ADDENDUM #2

NESBETT COURTHOUSE CARPET REPLACEMENT PROJECT #ANC-C-16-0012

Date: September 23, 2016

Photo 1
Addendum 02
09/23/16

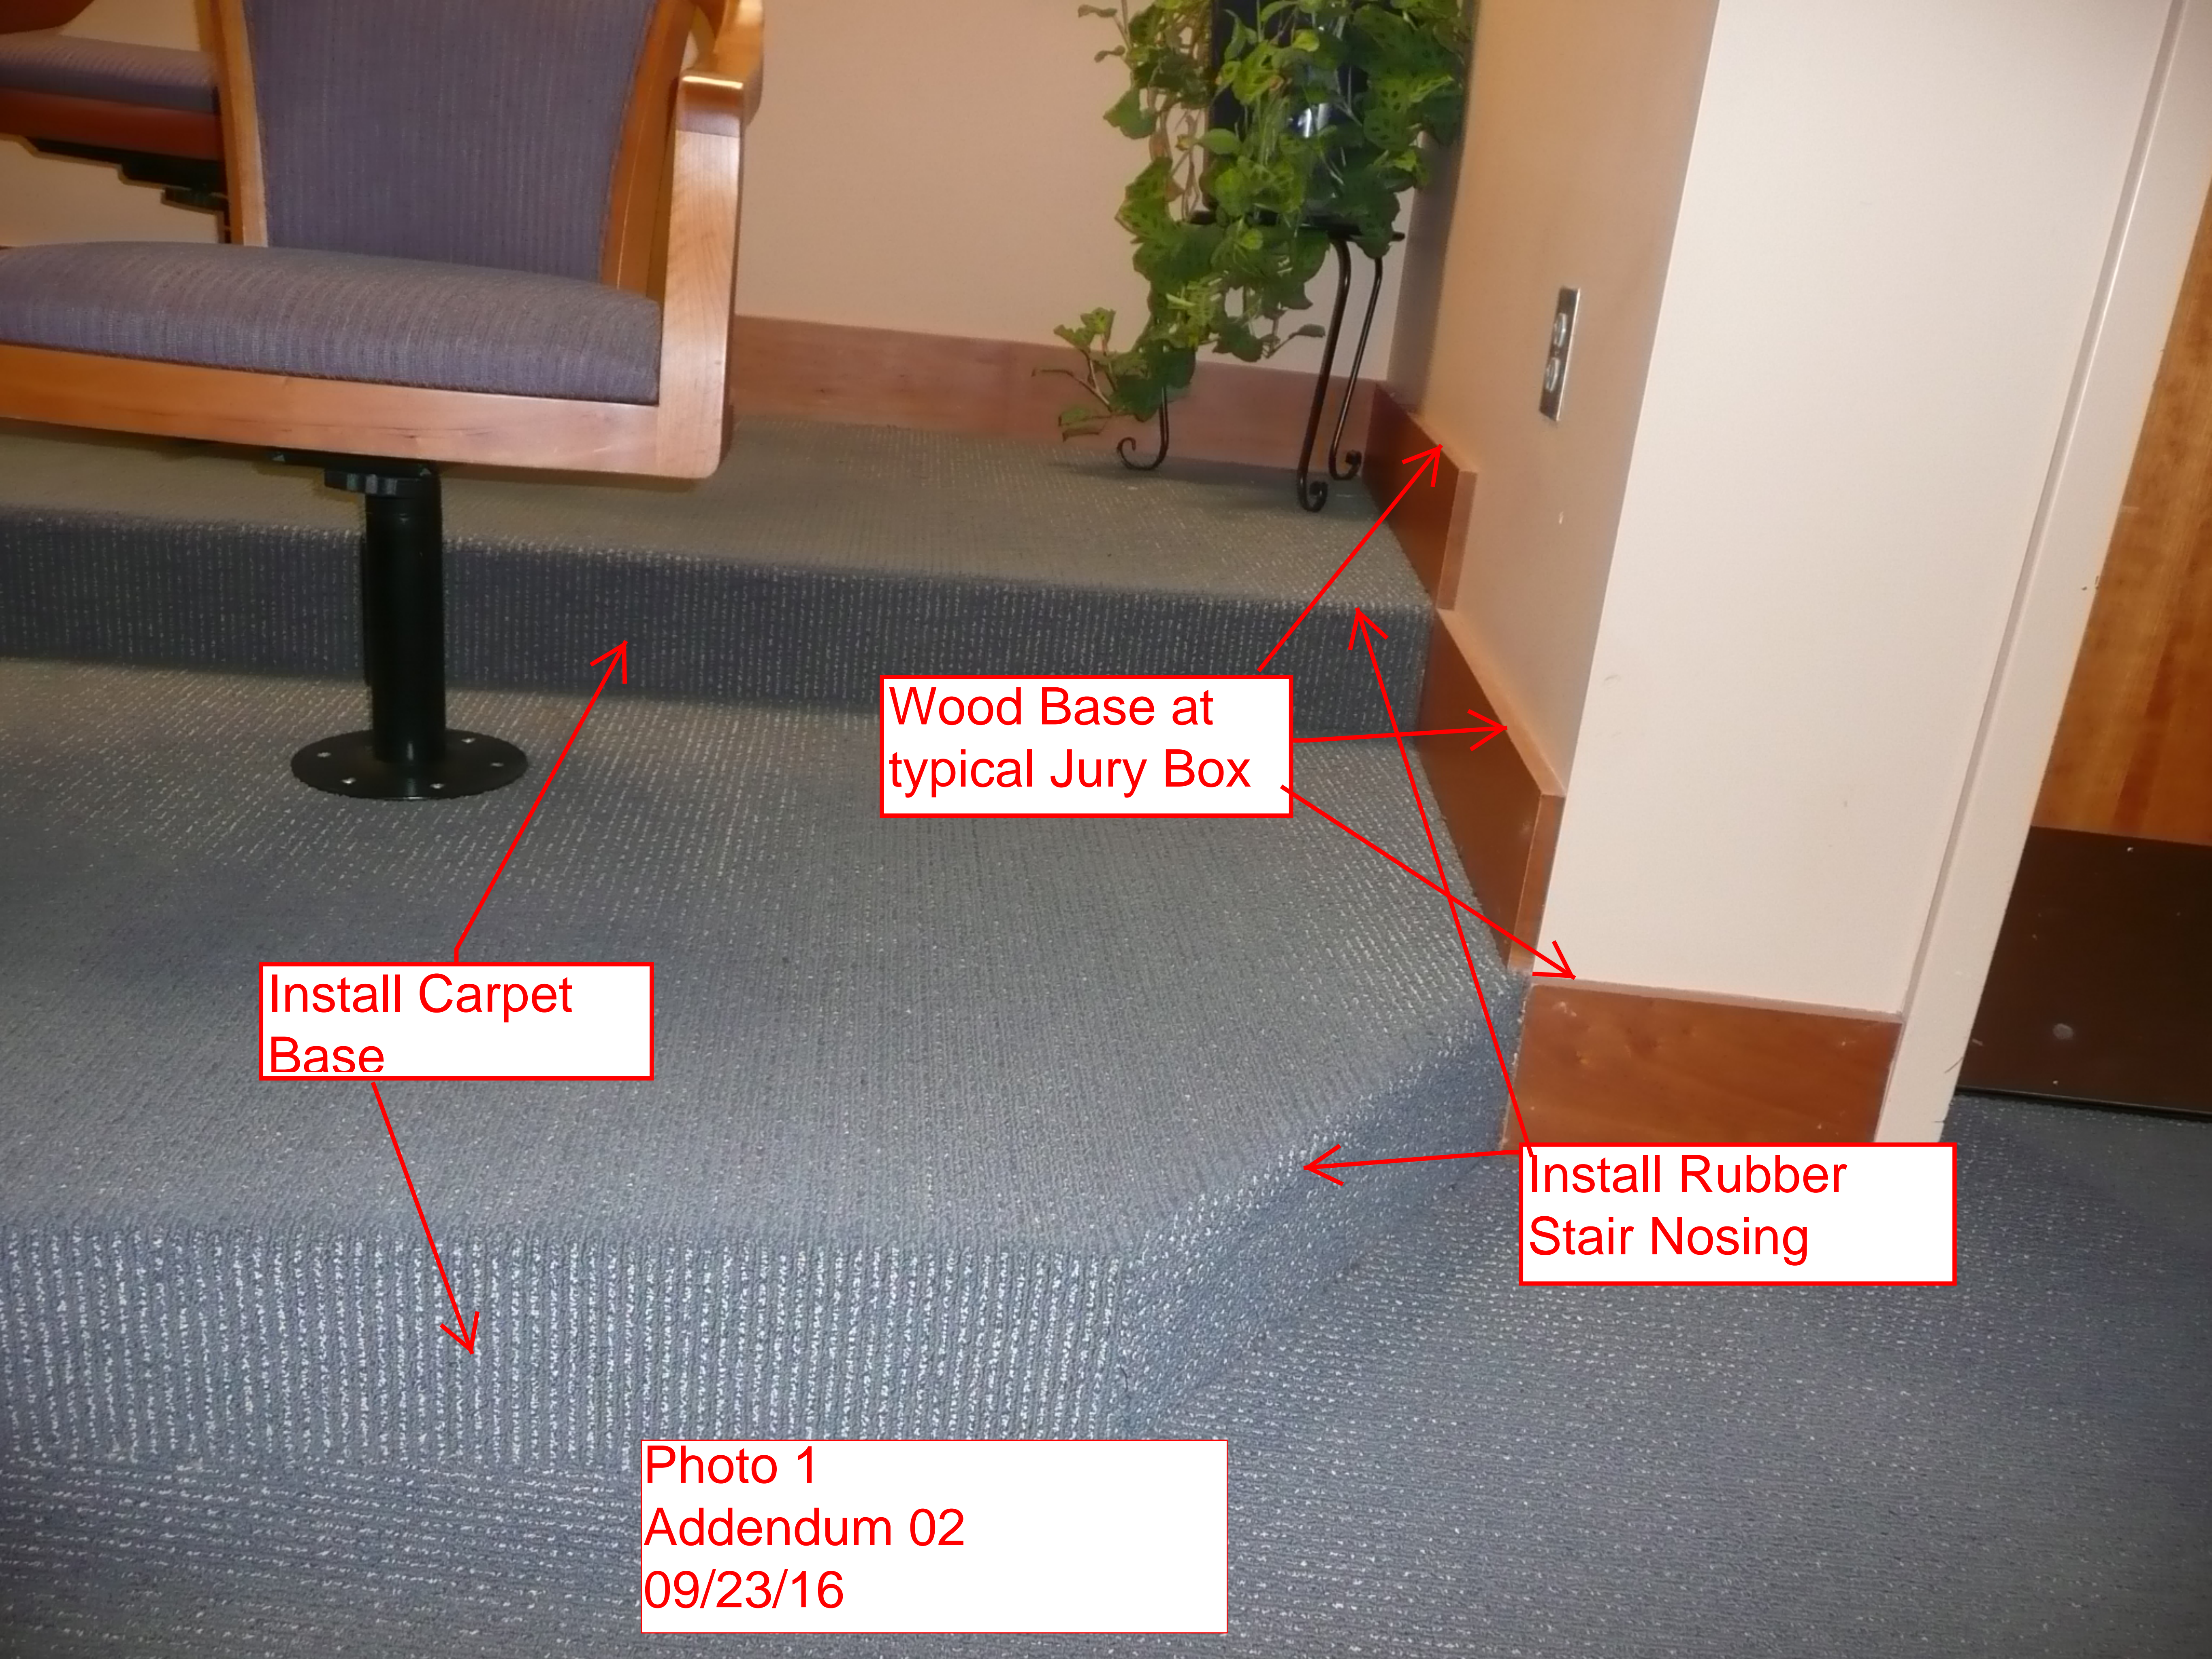
Install Carpet
Base

Install Rubber
Stair Nosing

Photo 2
Addendum 02
09/23/16

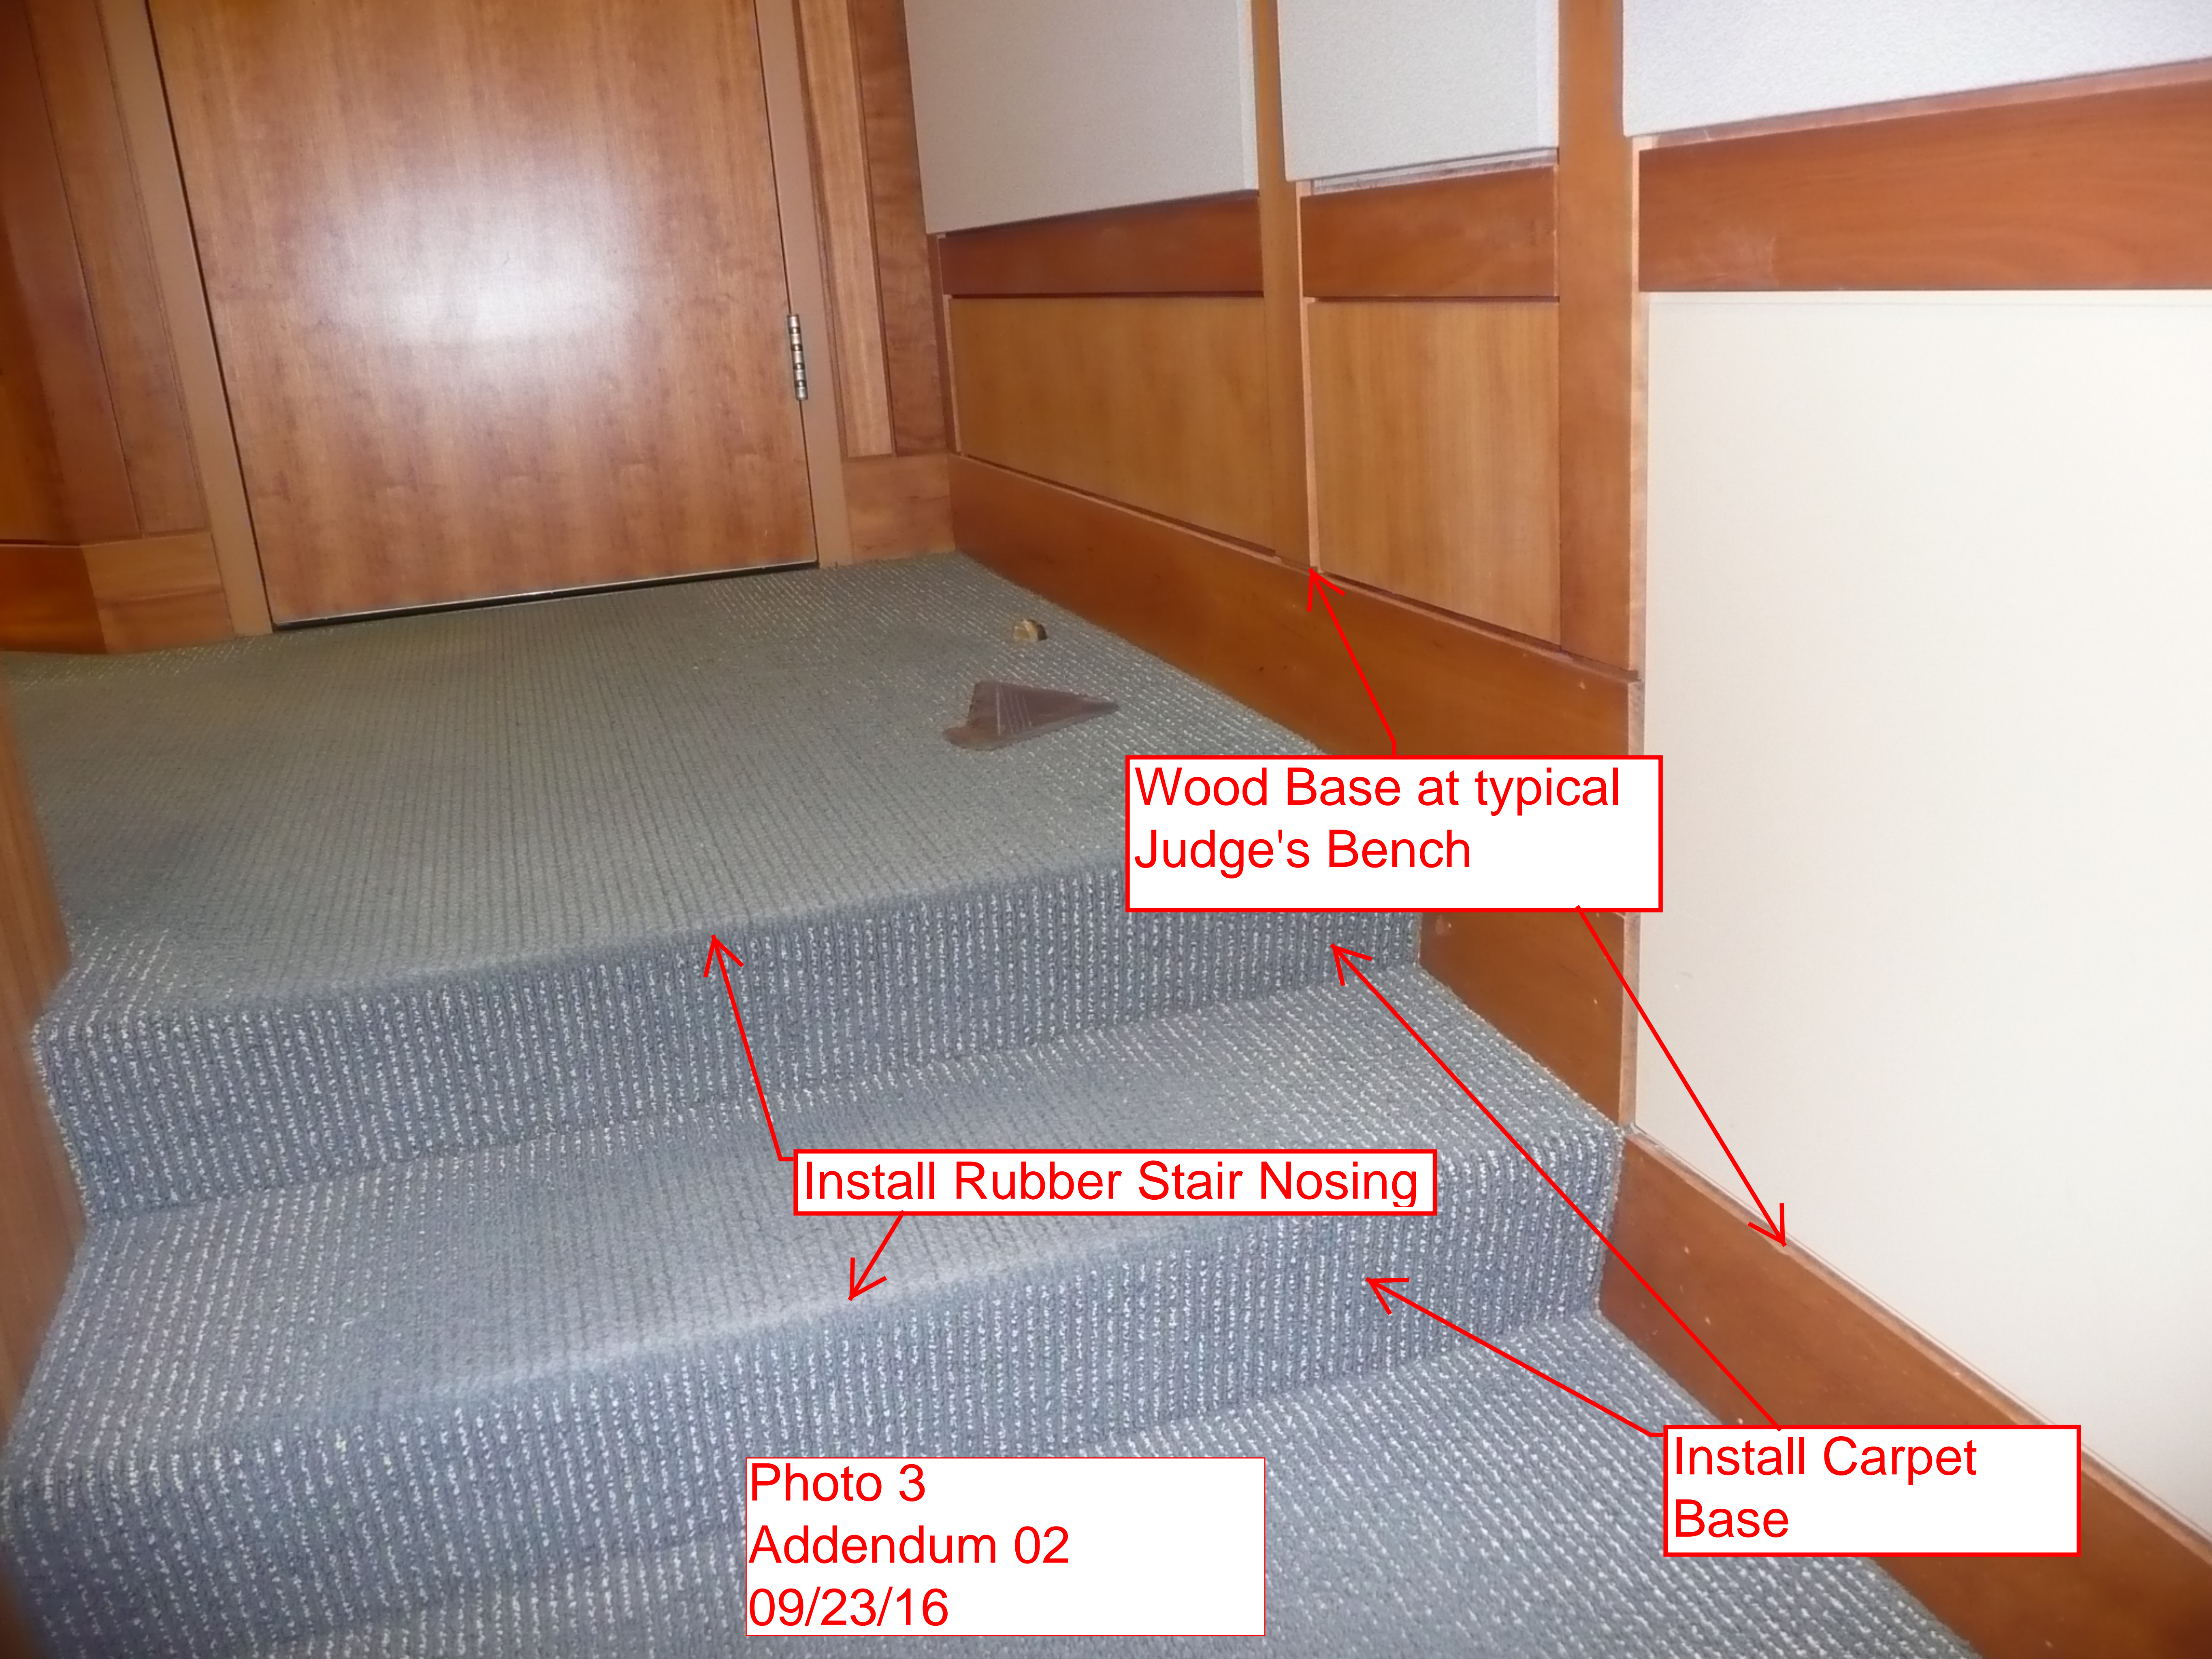
Wood Base at Typical Witness Stand
